ZONING COMMISSION AGENDA

CASE# 2-24-Z

A Zone Map Amendment from R-1 and B-1 to PD to allow an expansion to an existing multi-family residential area.

Staff Report, Case# 2-24-Z:

LANDSCAPE PLAN

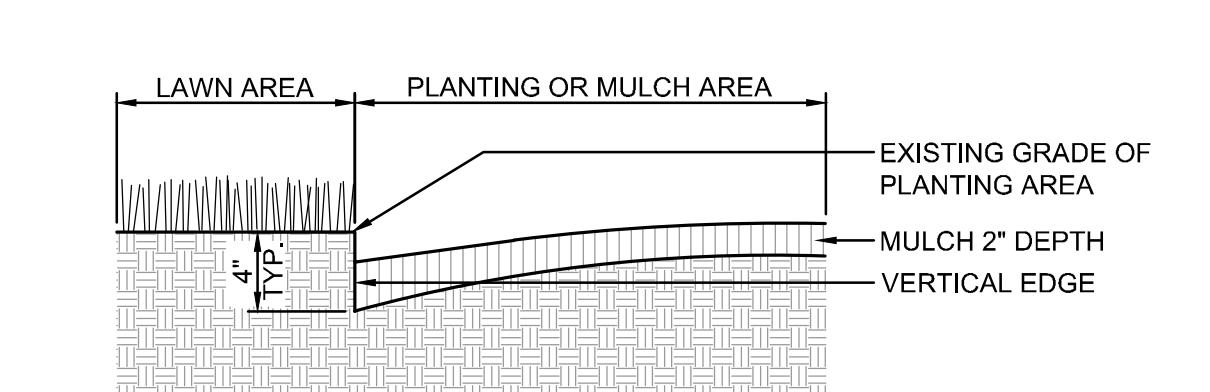
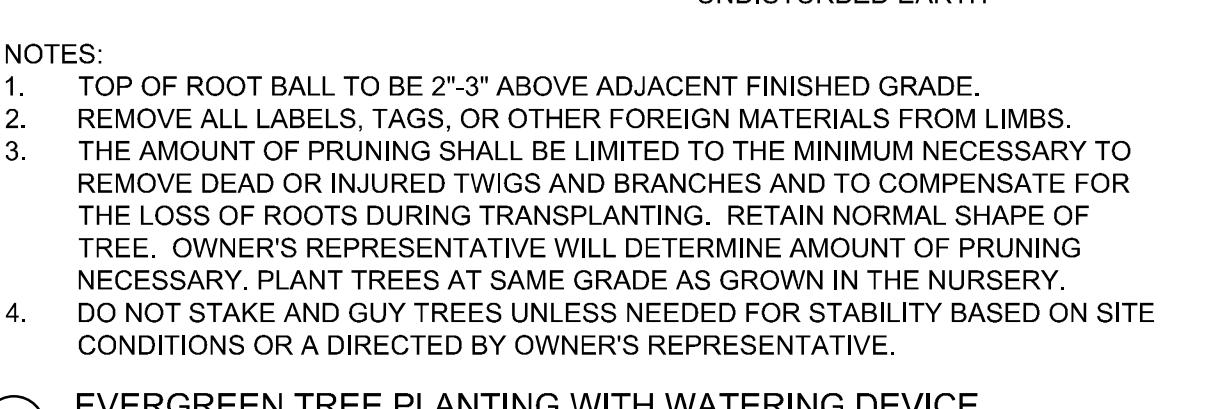
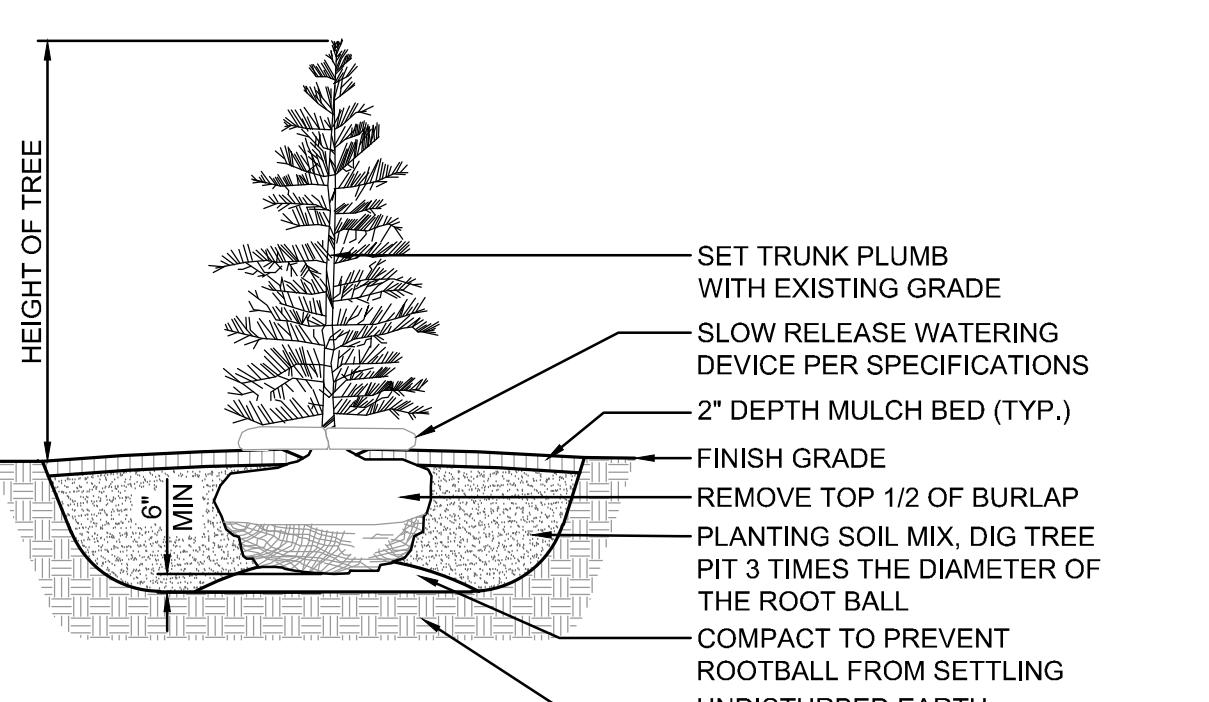
- 4) The landscaping plan must be updated to better reflect the proposed plantings. Additionally, the staff recommends some evergreens or street trees to be shown / planted on the berm in the front of the property. All landscaping buffers should be marked as preservation areas, and any vegetation disturbed should be repaired, supplemented, or replaced. *This is an item that can be addressed administratively by staff.*

BUILDING TYPE 5 FRONT ELEVATION

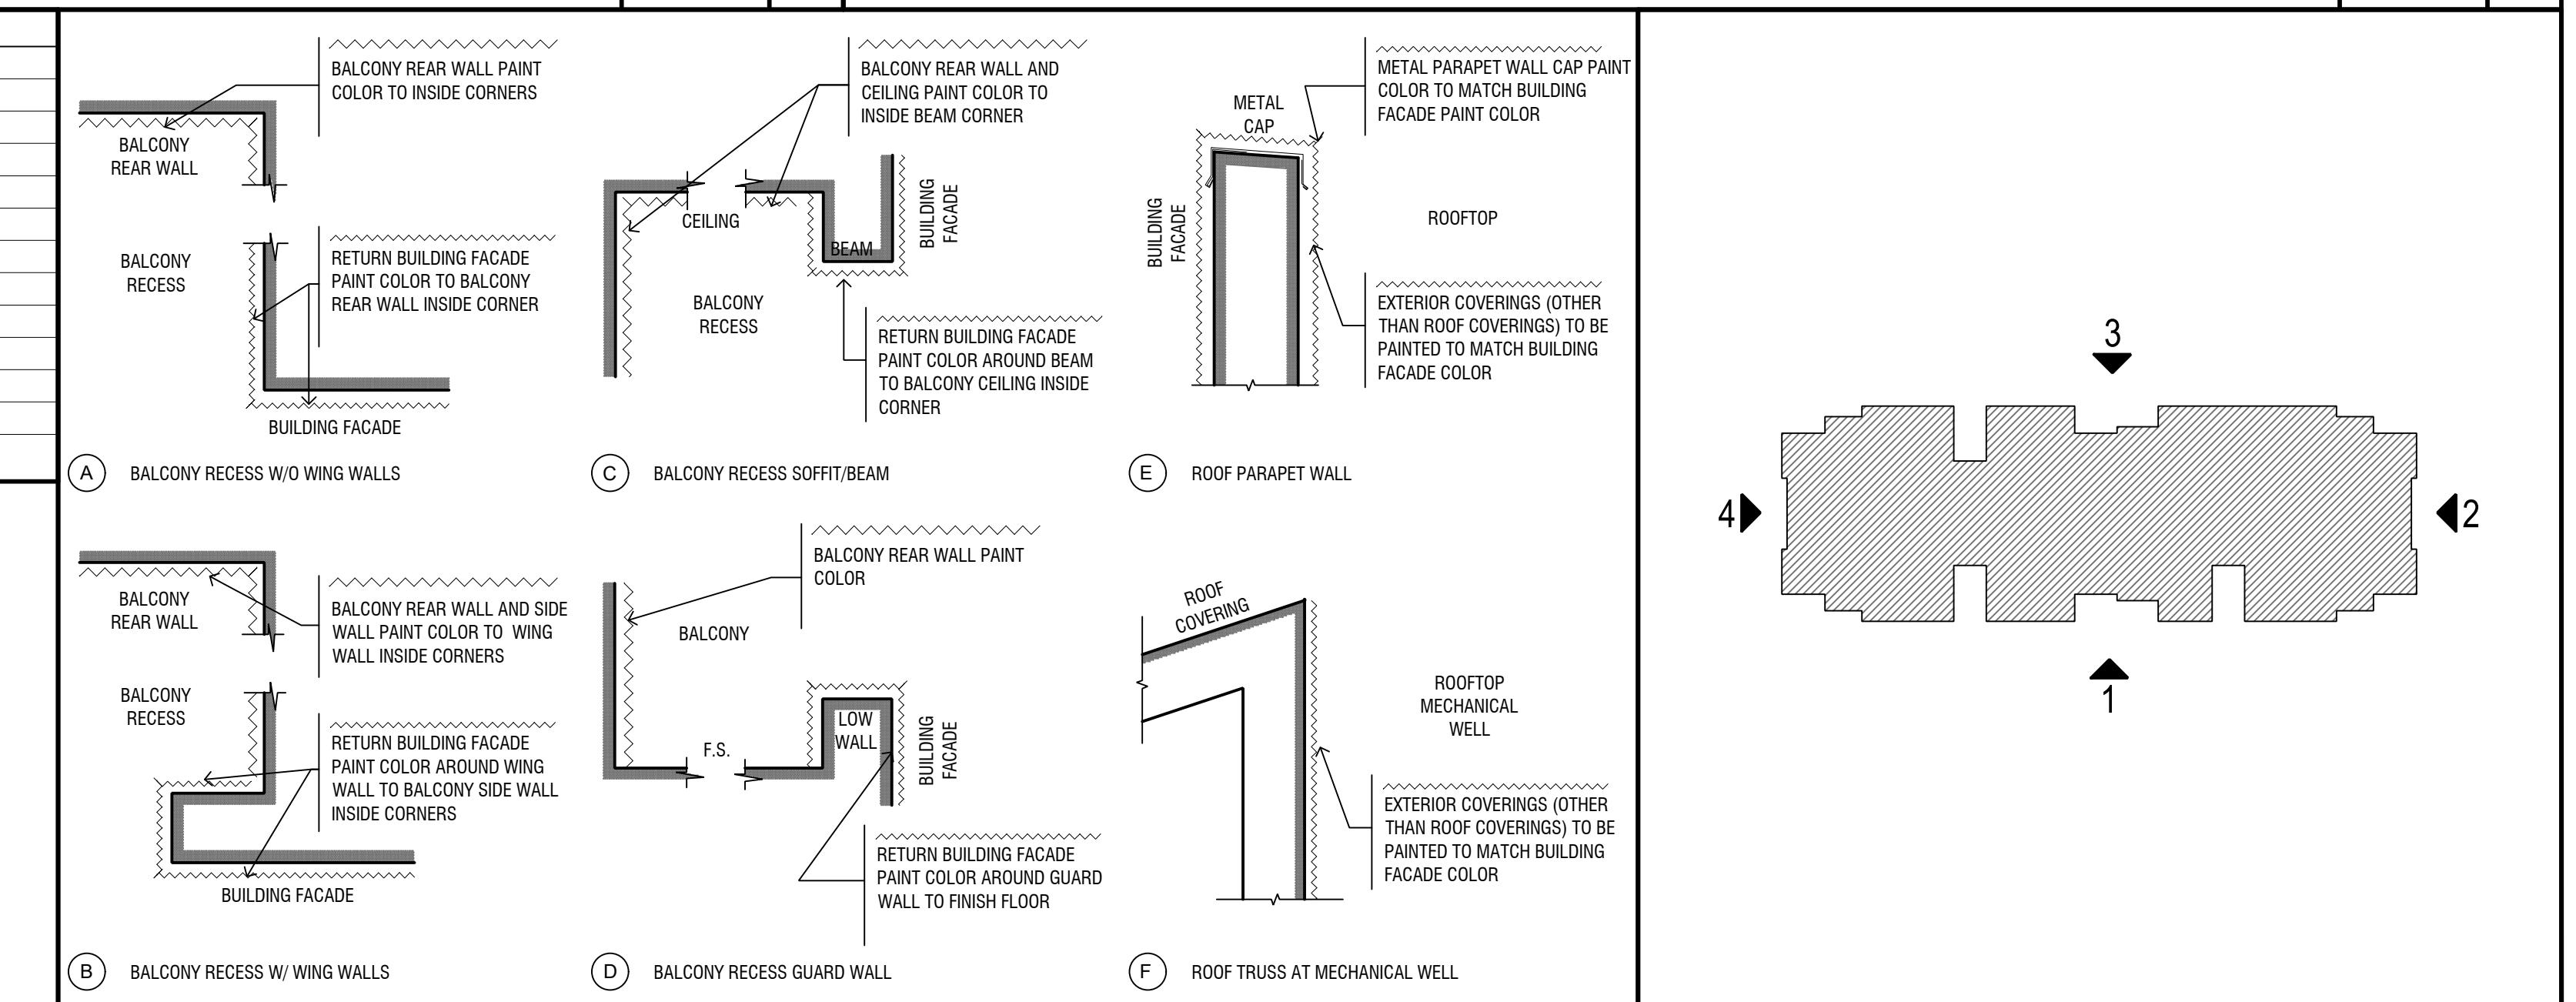
- 5) The Ohio Pike Corridor Overlay Area within the Township's Horizon 2030 Comprehensive Plan acknowledges that "*the use of high-quality building materials and innovative design strategies is strongly encouraged in order to continue to promotion of high-quality development along this corridor.*" With this in mind, staff finds that the proposed buildings need to contain some brick, wood, stone or simulated stone, or other masonry or veneer (excluding stucco, concrete block, and the like), sufficient to meet the "traditional building materials" definition in Appendix A of the Union Township Zoning Resolution. *This is an item that could be addressed administratively by staff.*
